RE: WR Permit 63-31243 - Technical Review of the BU Field Report's Recommended Diversion Rate

This memo is a summary of my technical review of the diversion rates calculated and presented in the field exam of water right permit 63-31243.

Belmont Well #1 (9RCHC (7 stage, 50 hp) Goulds Pump)

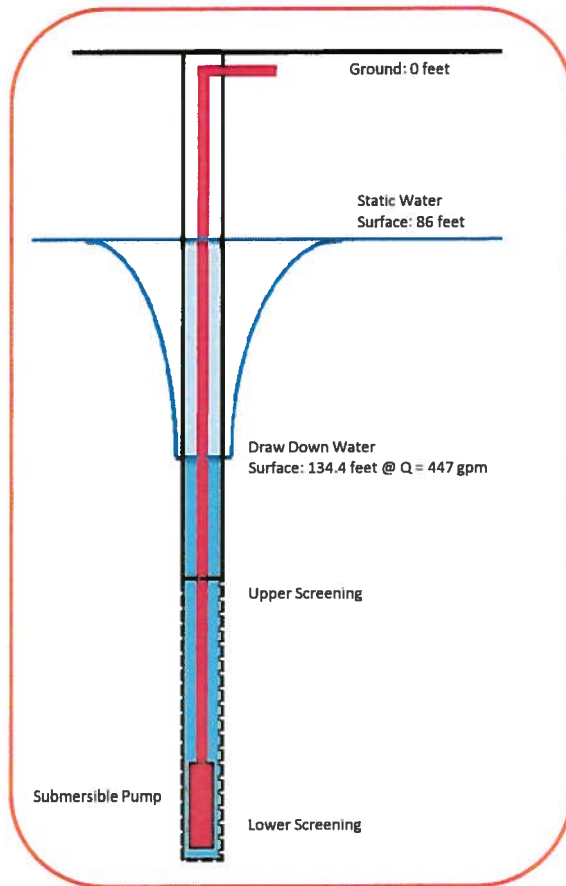
My review of the flow rate calculation left me with several questions. Specifically, I was unsure of where the draw down value of 22.5 feet used to calculate the specific capacity term came from. I was also unsure of where the values used for deriving friction head loss and minor losses came from. In general, I was unsure why SPF assumed a TDH and solved for a discharge pressure, instead of calculating a TDH based on actual conditions and using the pump curves to determine the respective pumping rate.

for a flow rate that changed by less than 0.1% between iterations. I solved for a TDH of 202.7 feet (vertical head = 107.3 feet, pressure head = 92.4 feet, and friction head = 3.0 feet), which from my analysis of the pump performance curves corresponded to a flow rate of 740 GPM (i.e. 1.65 CFS).

City of Nampa - Belmont Well #2

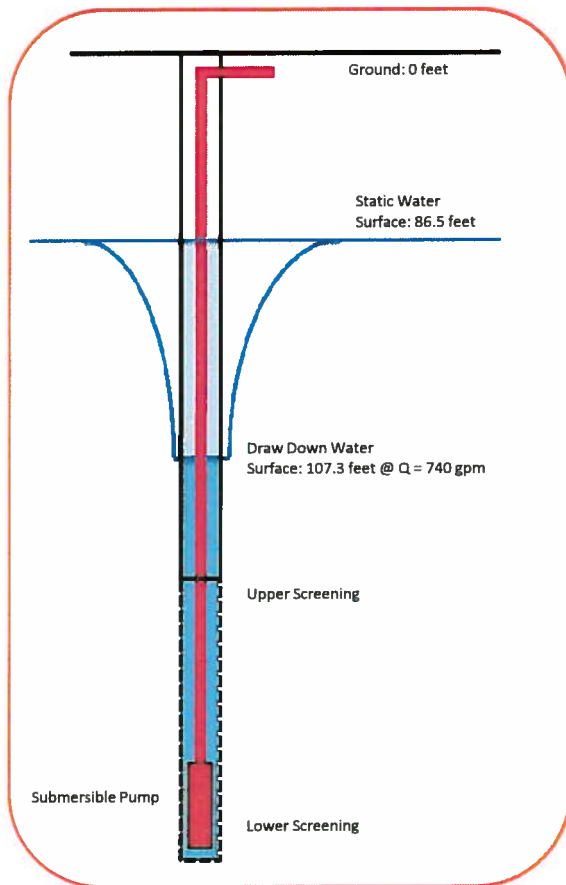
Similar to Belmont Well #1, I was unsure of where the values used to calculate friction head and head loss came from. It also appeared to me that there was some inconsistency in the flow rates used to calculate various values (e.g. 425 GPM vs. 455 GPM vs. 435 GPM).

Using the same approach I outlined for Belmont Well #1, my review required 5 iterations to solve for a flow rate that changed by less than 0.1% between iterations. I solved for a TDH of 246.1 feet (vertical head = 134.4 feet, pressure head = 92.4 feet, and friction head = 19.3 feet), which from my analysis of the pump performance curves corresponded to a flow rate of 447 GPM (i.e. 1.00 CFS).

Although my approach and methods for determining the likely operating point flow rate was different than the field examiner's report I arrived at a very similar values (455 vs. 447 gpm). Therefore I recommend 1.00 cfs be used in establishing the combined diversion rate.
